SERVICE LETTER 216

Cessna 208 Caravan 8000A & 8750A Hydraulic Pump Replacement

Aircraft Makes/Model(s):	Float Model(s):	Compliance: Optional	By: MAB
Textron Aviation 208	8000A & 8750A	Part Number: 1011602	Approved: SDW
		Date: 5/7/2021	Revision: A

DISCONTINUED
HYDRAULIC PUMP 8A09000-031

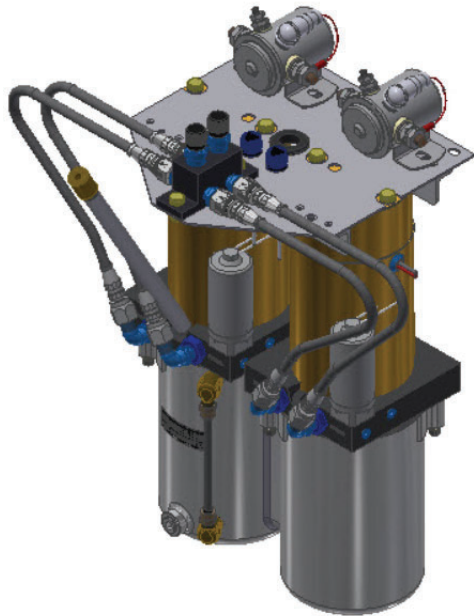
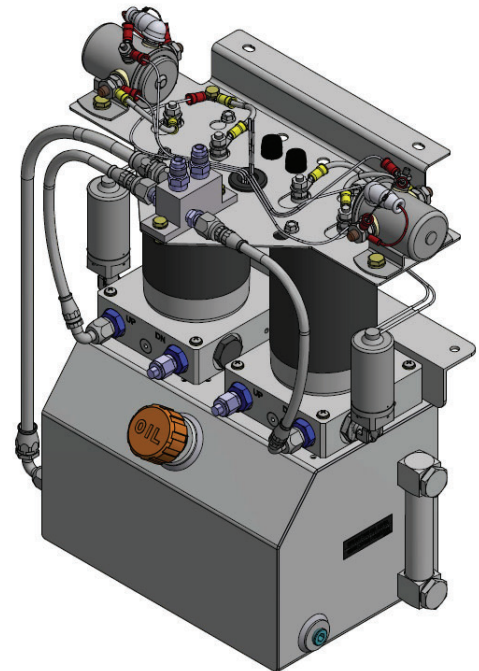
Hydraulic Pump Assembly p/n 8A09000-031 has been discontinued. This service letter provides the option to replace it with a new pump p/n 1011404.

NEW
HYDRAULIC PUMP 1011404

SOLENOID SCHEMATIC

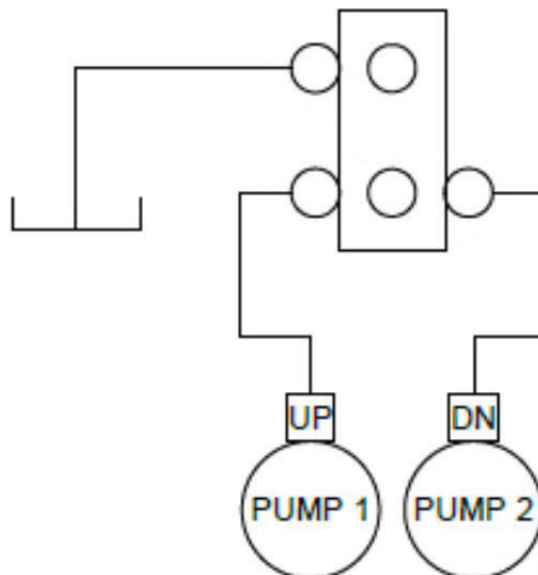
1. Pull Pump 1 and Pump 2 circuit breakers.
2. Remove and cap both pressure and return hydraulic lines on hydraulic pump manifold 6A09000-027.
3. Remove GA1 and GA4 wires (12 ga) from electrical solenoids on hydraulic power pack 8A09000-031.

4. Cut GE10 and GE11 wires (20 ga) at butt splice connection. If aircraft has G1000 avionics, cut GE21 and GE22 (20 ga) wires.
5. Unbolt and remove hydraulic power pack 8A09000-031 from pump mount assembly.
6. Install new hydraulic power pack 1011404 onto pump mount assembly using existing hardware.
7. Install pressure and return line to hydraulic pump manifold. Refer to hydraulic schematic.
